1. Site Plan Review – J & H Family Store, 917 E. Main Street

CITY OF OWOSSO PLANNING COMMISSION STAFF REPORT

DATE: April 15, 2019
TO: Planning Commissioners
SUBJECT: Site Plan Request – 917 E. Main Street, Parcel # 050-112-000-034-00

A4.01

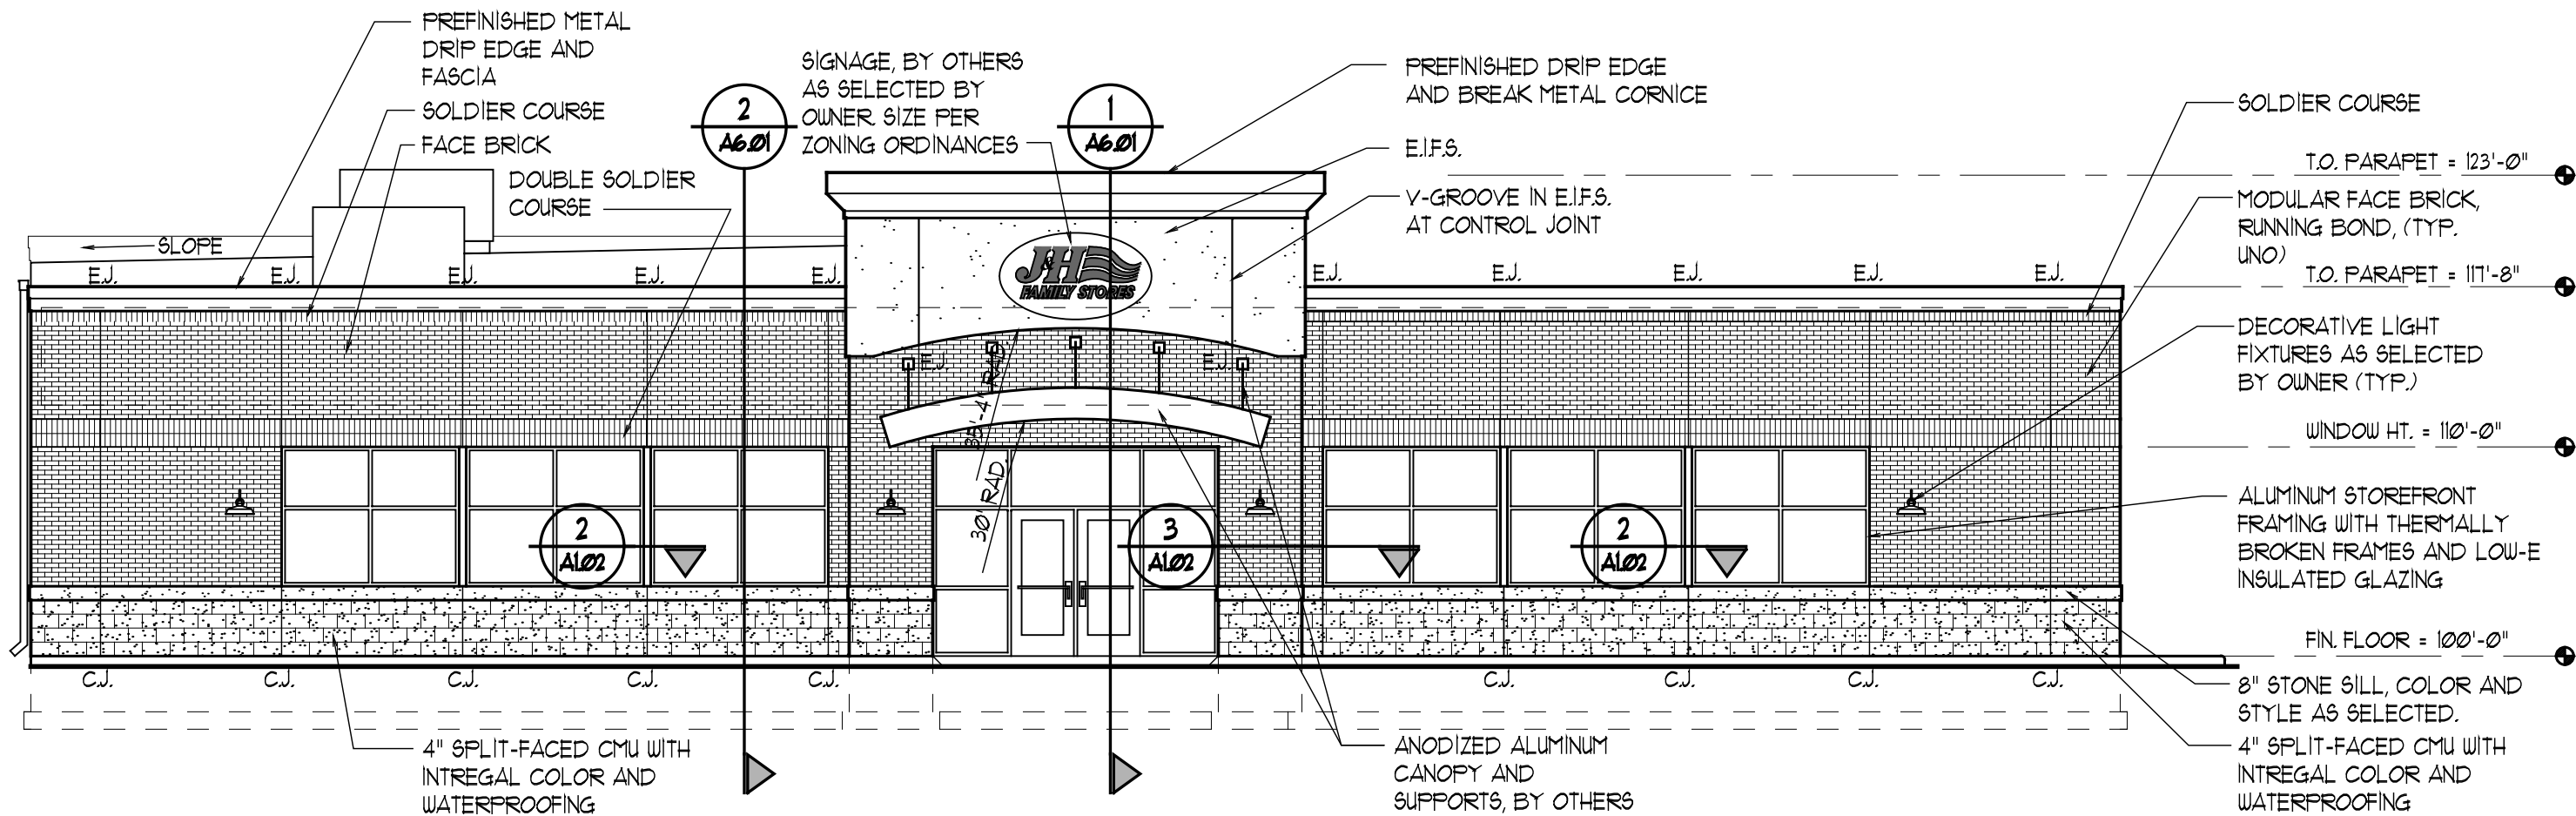
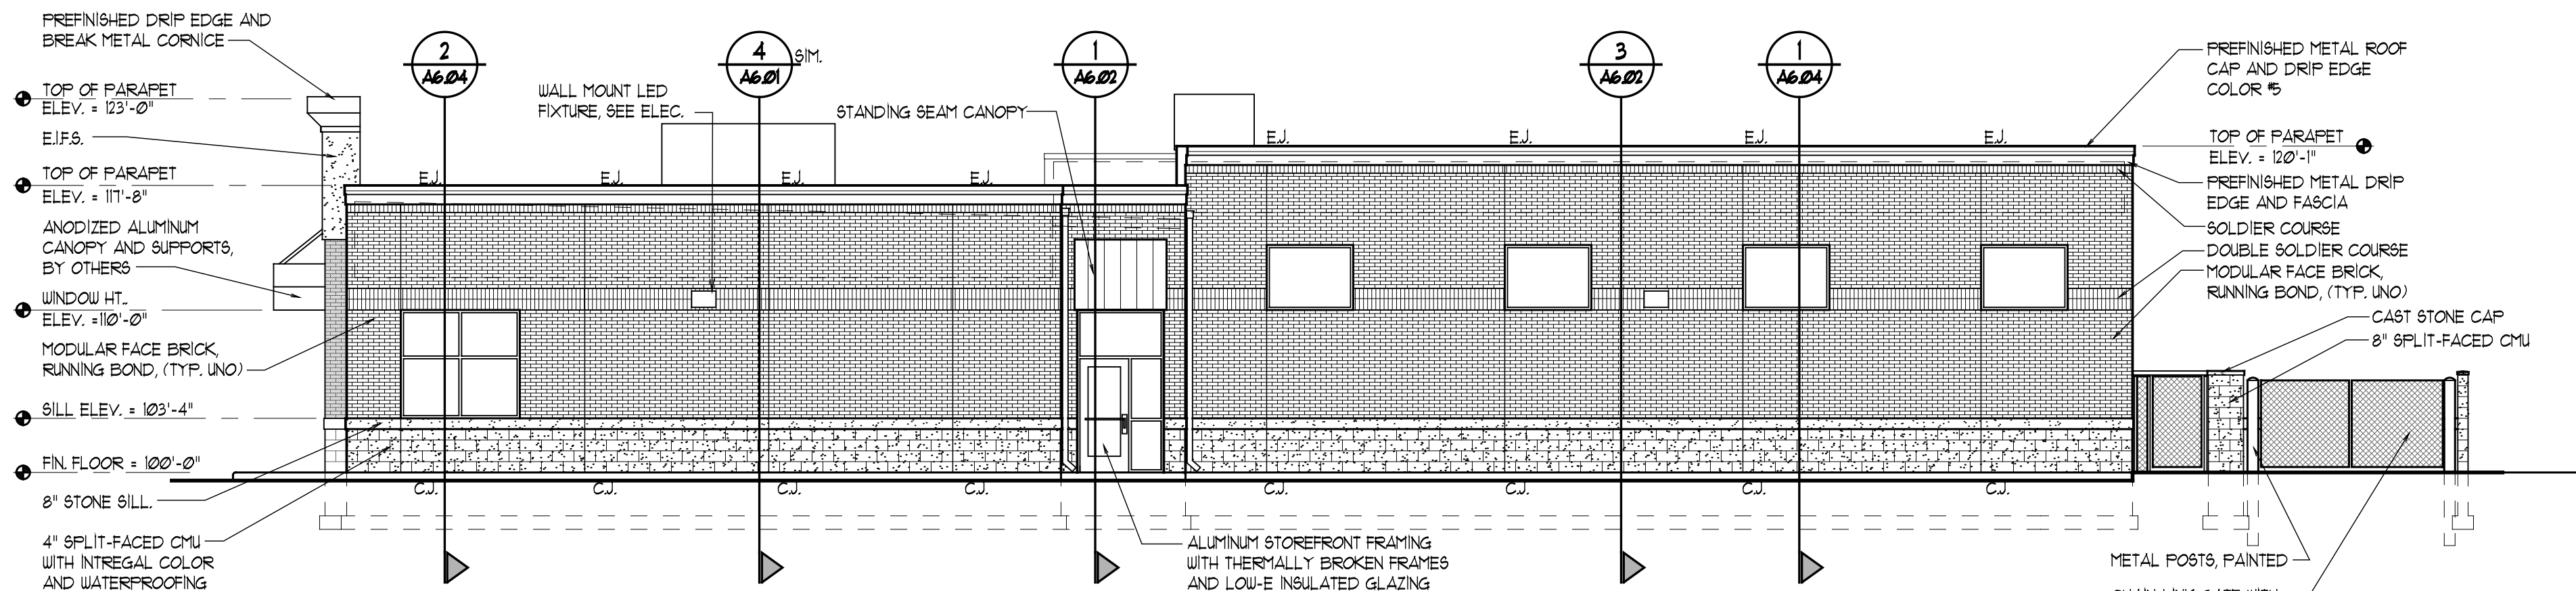
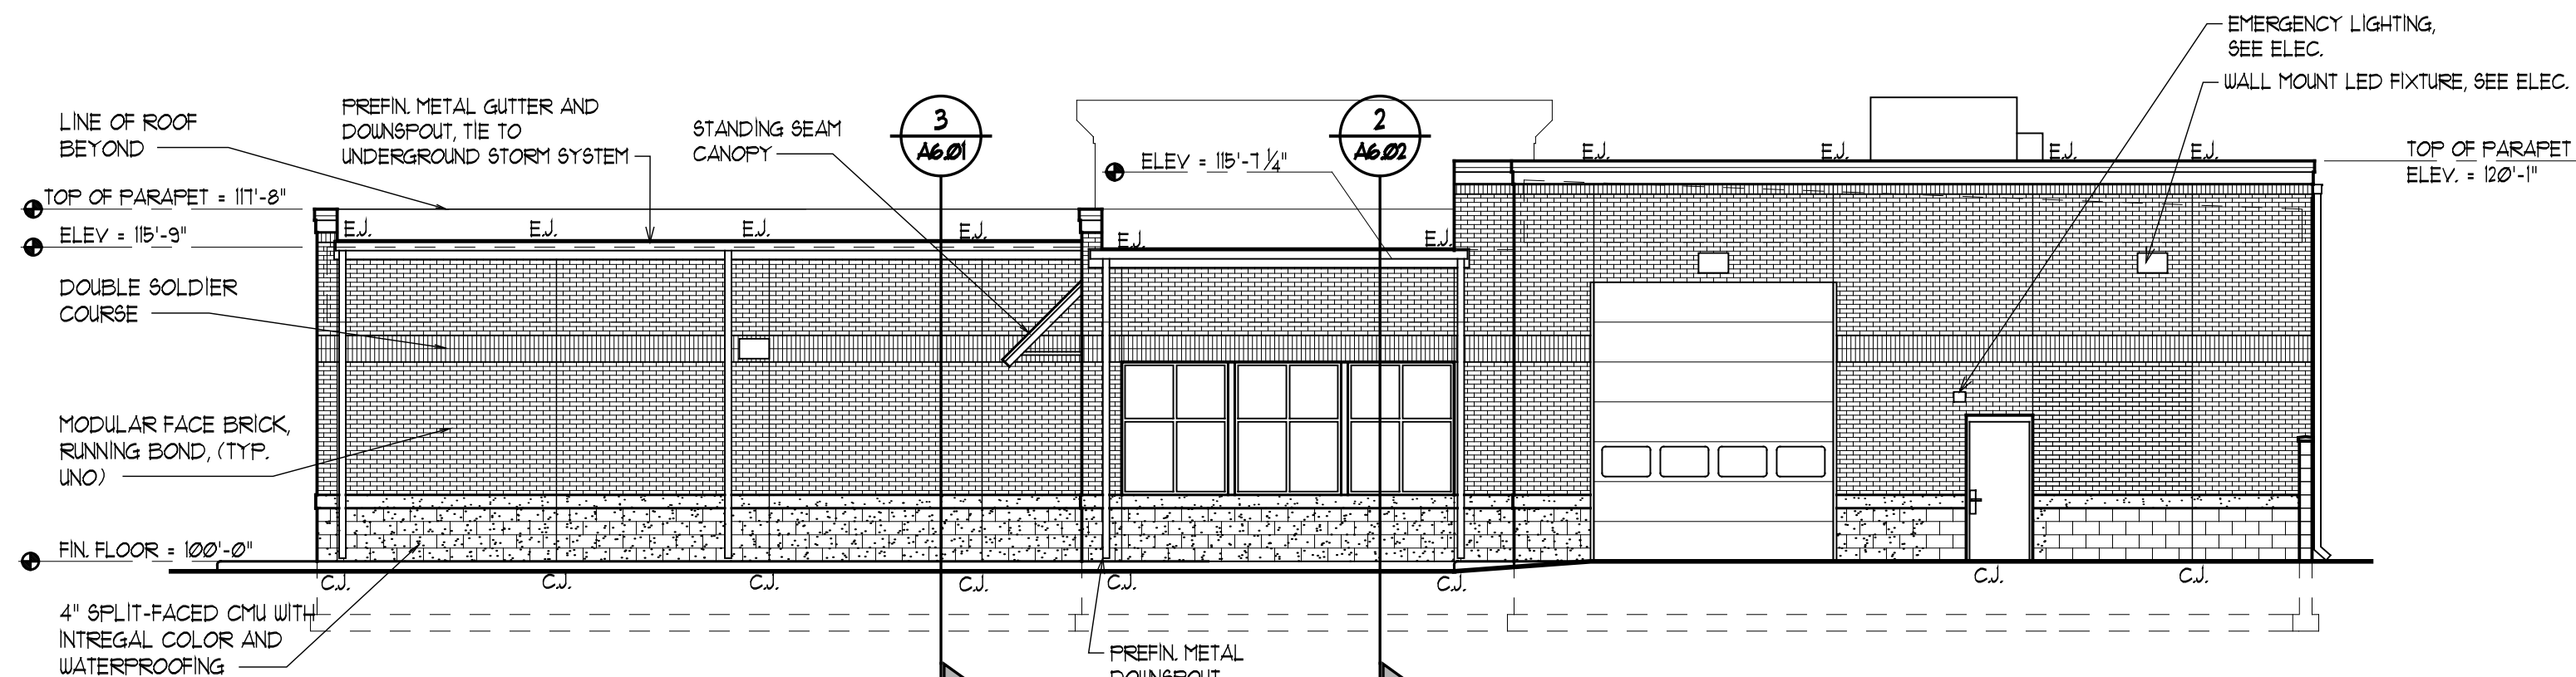
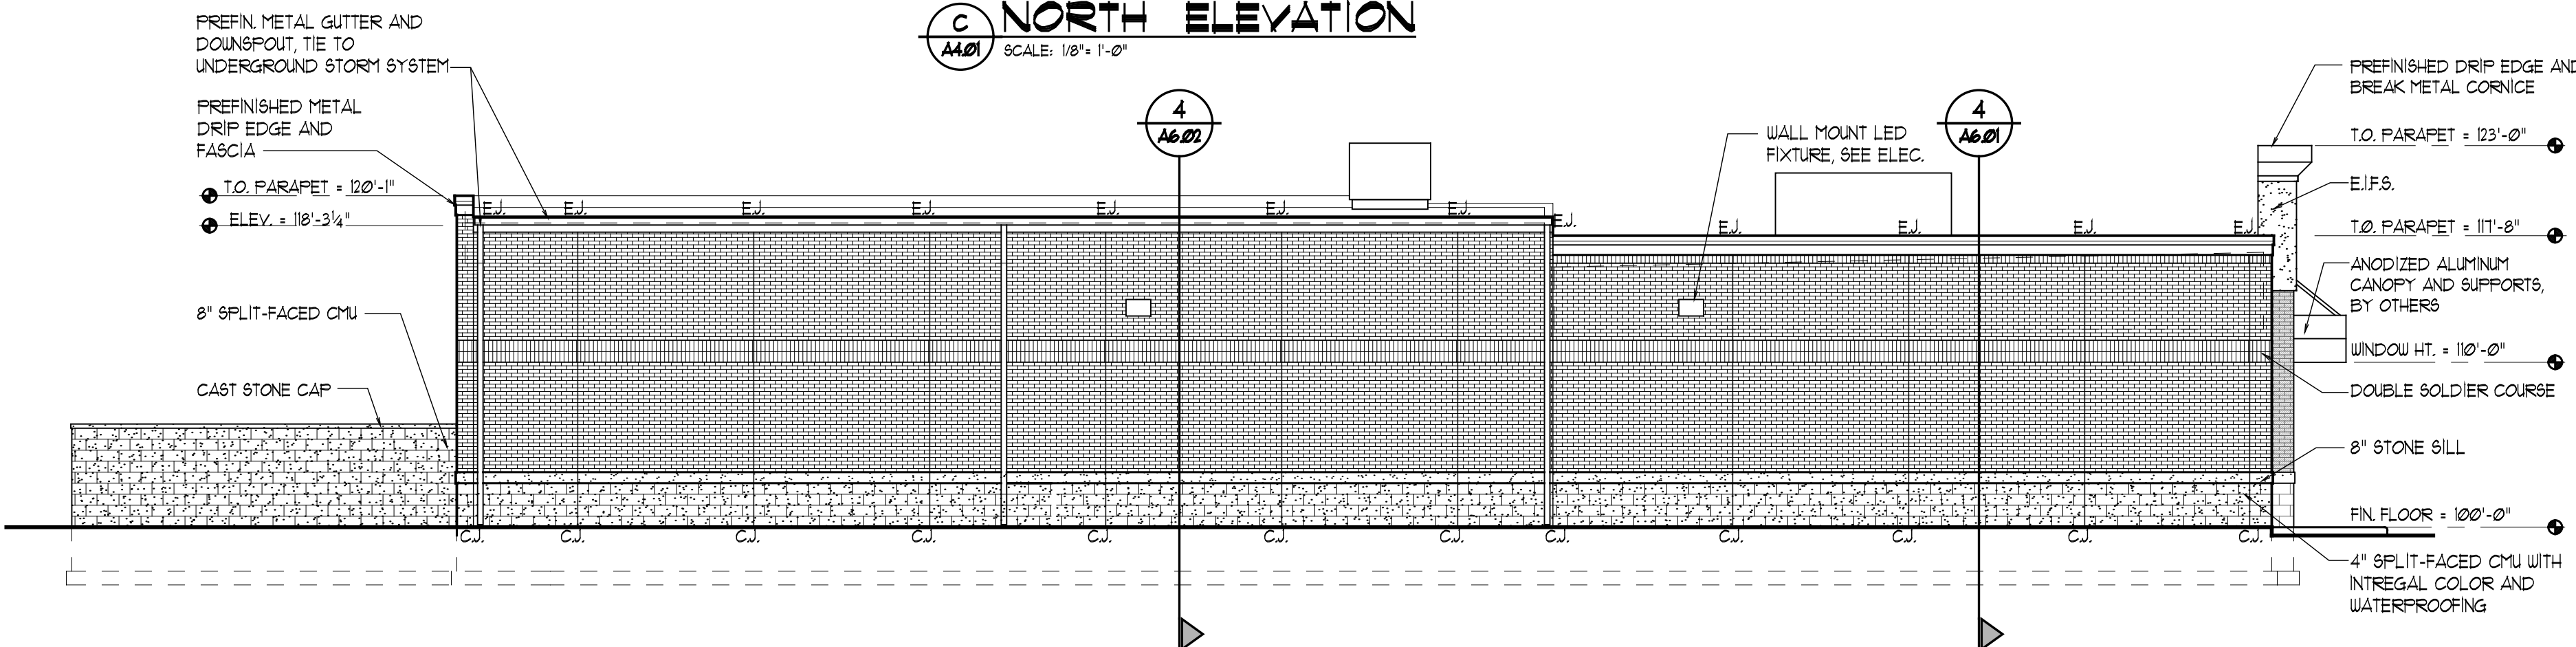
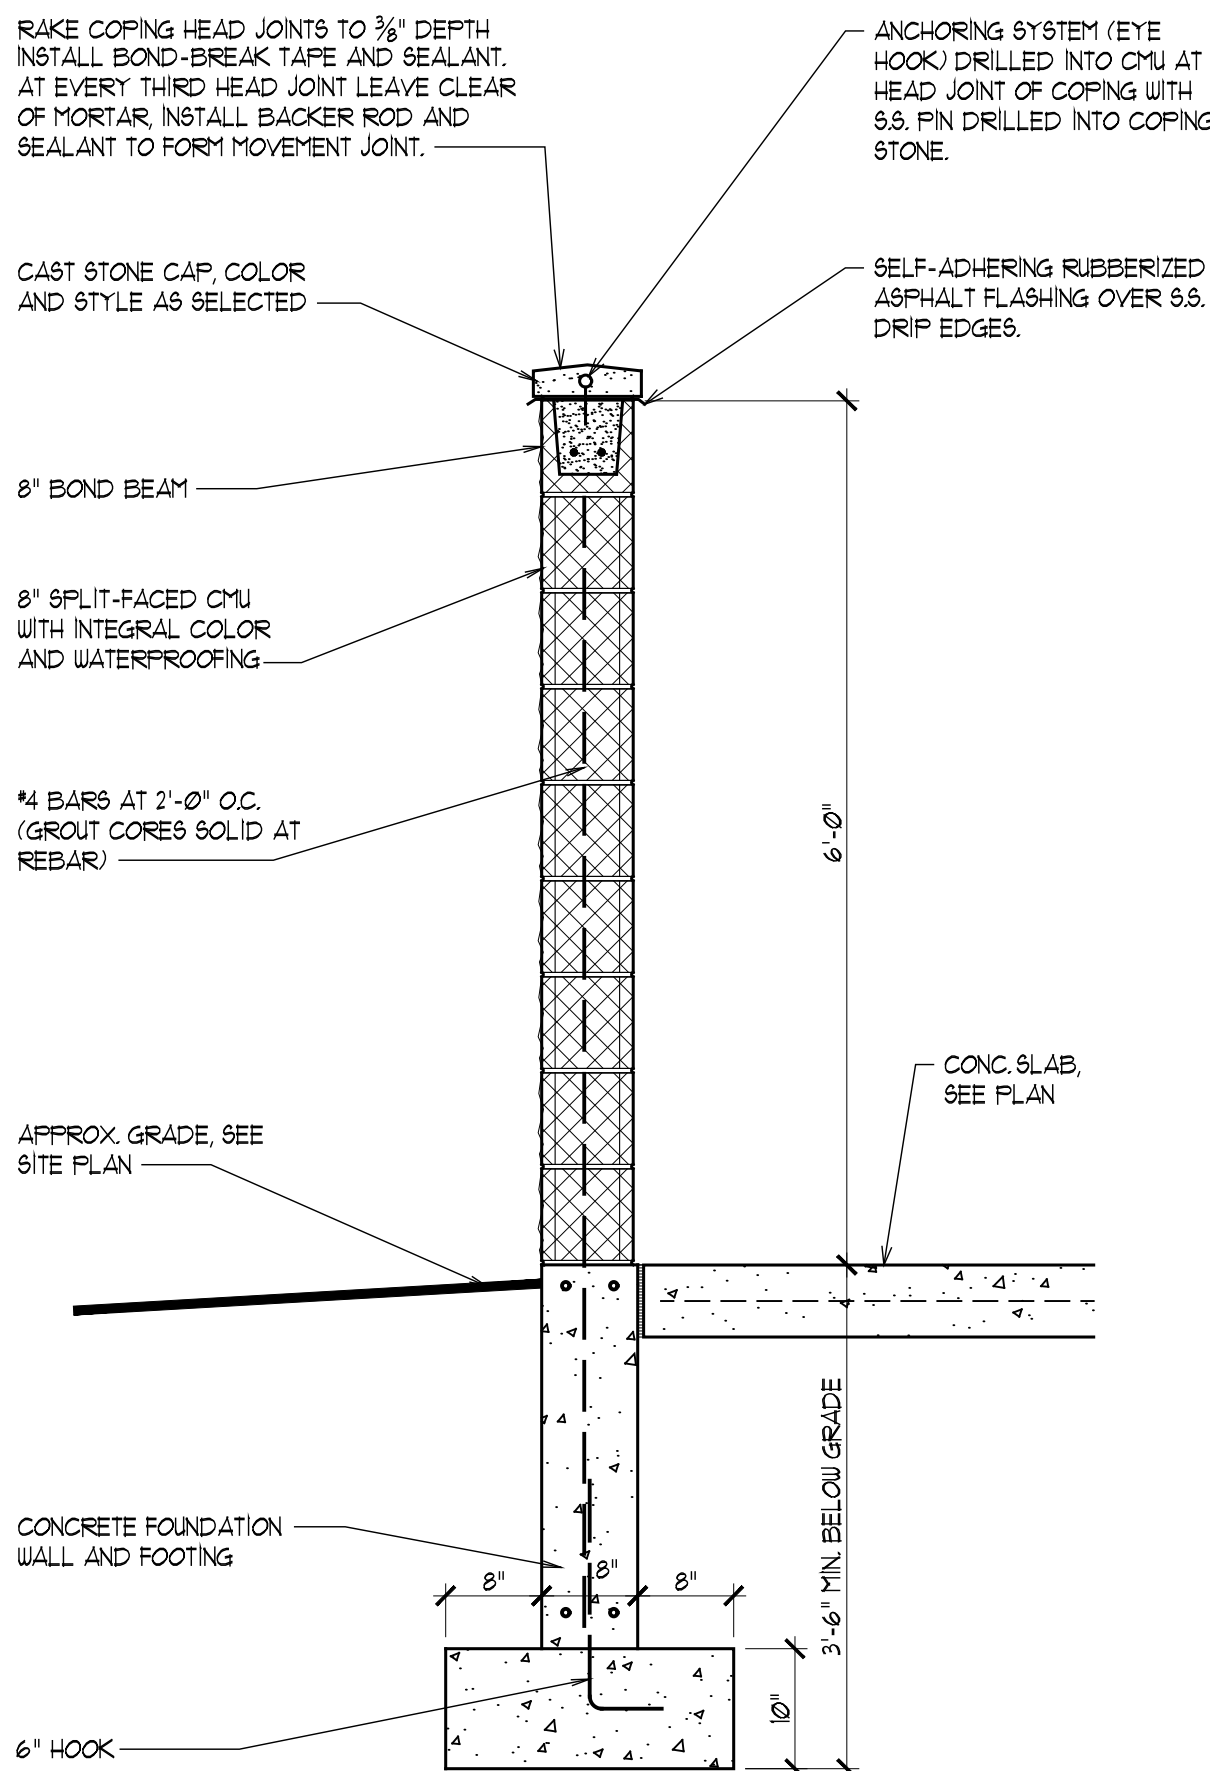
9. Provide stamped architectural drawings.
10. Remove the dumpster enclosure details provided on sheet C3. The details conflict with the details provided on Sheet A4.01. Dumpster must meet front yard setback requirements.

13. Per Sec. 38-397 (a) (3) window area or spandrel glass shall make up at least twenty percent (20%) or more of the exterior wall area facing a principal street(s). **Window area east wall shall be a minimum of 20% glass/window – variance required.** **Owner is adding glass to the east façade but not able to provide additional glazing up to the 20% requirement and will be requesting a variance.**

15. Per Sec. 38-397 (a) (5) overhead doors shall not face a public street or residential district. The planning commission can modify this requirement upon a determination that there is good or necessary cause and the visual impact will be moderated through use of building materials, architectural features and landscaping beyond that required by the ordinance. Per Sec. 38-397 (c) (2) mechanical and service features such as gutters, ductwork, service doors, etc. that cannot be screened must be of a color that blends in or compliments the color of the building.
